**TCP/11/16(622) – 19/01690/FLL – Erection of a shed, 10  
Kinmond Drive, Perth**

## **REPORT OF HANDLING**

## REPORT OF HANDLING

**PROPOSAL:** Erection of a shed

## Block Plan + Elevations

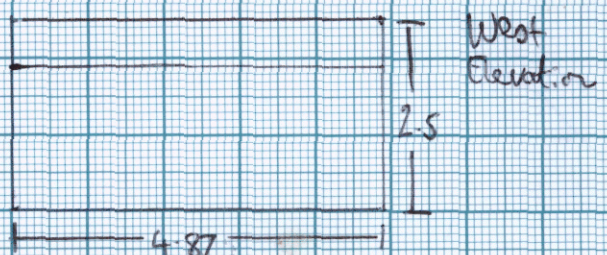
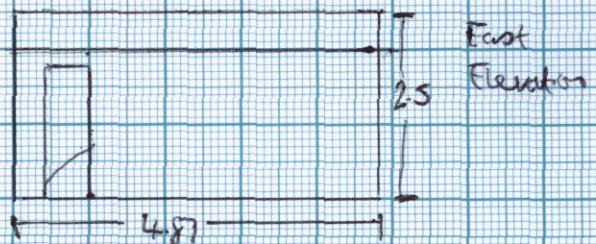
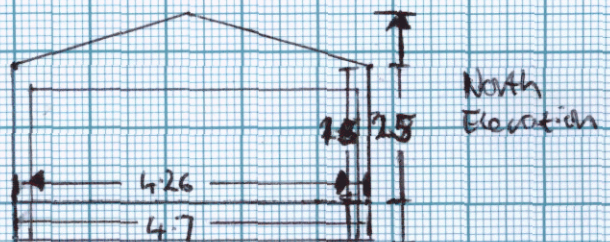
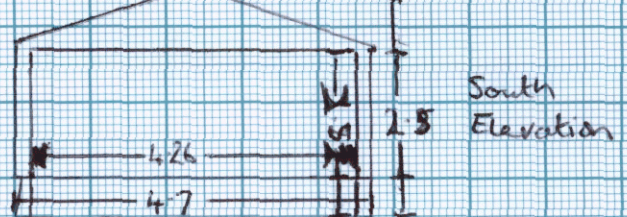
The footprint of the proposed shed measures 4.87m by 4.7m and will reach a maximum height of 3m. It is of standard construction finished in timber, however, no detail has been provided as to whether vertically or horizontally hung. The drawings indicate the roof will be finished in epdm rubber.

The shed will be positioned approximately 3.4m from the rear wall of the dwellinghouse, 0.3 metres from the west boundary, 1.2m from the north boundary and 2.4m from the east boundary.

To summarise the proposed amendments, the footprint has been reduced by approximately 2.4 sqm, its width increased by 200mm with its length reduced by 730mm. Its roof design is to be pitched and there are no windows proposed within the structure. In terms of its location, it will be sited much the same distance to the western boundary as the previous application, the distance to the eastern boundary will increase by 300mm, the distance to the northern boundary will be slightly more by approximately 300mm as will the distance between the rear wall of the dwellinghouse to the proposed shed which will be an increase of 900mm.

Whilst the back garden measures approximately 78 square metres as identified on the submitted block plan the usable area is closer to 70sqm, therefore, for the purposes of calculating remaining usable garden space measurements are taken from 70sqm.

The proposed shed raises significant concerns in terms of its excessive footprint when compared to the modest size of the rear garden in which it is proposed. The footprint has been reduced by approximately 2.4sqm bringing the total decrease

across all applications to approximately 5.2sqm which is still not considered to be enough to overcome the previous reasons for refusal. The existing usable area of rear garden ground is particularly small measuring approximately 70sqm and the proposed shed will result in around 45sqm remaining after development. The sketch below demonstrates the extent of built development within the plot and the remainder of usable garden ground, should this proposal be approved.

The area is generally characterised by open-plan front gardens and as such private garden ground is located to the rear. I do not feel it is appropriate to remove such a large area of what is the only private amenity space. The dwellinghouse is a 3 bed and whilst not directly related to this proposal, the draft placemaking guide specifies it is good practice to provide a minimum of 80 sqm for a 3 bed dwellinghouse. The sketch above clearly demonstrates the remaining garden ground (hatched green) is not of sufficient size to serve a 3 bed property.

In this regard I consider the area retained after development is inadequate in size to satisfactorily accommodate this development without affecting the residential amenity of the existing house and as such is contrary to policy RD1 sub criterion (c).
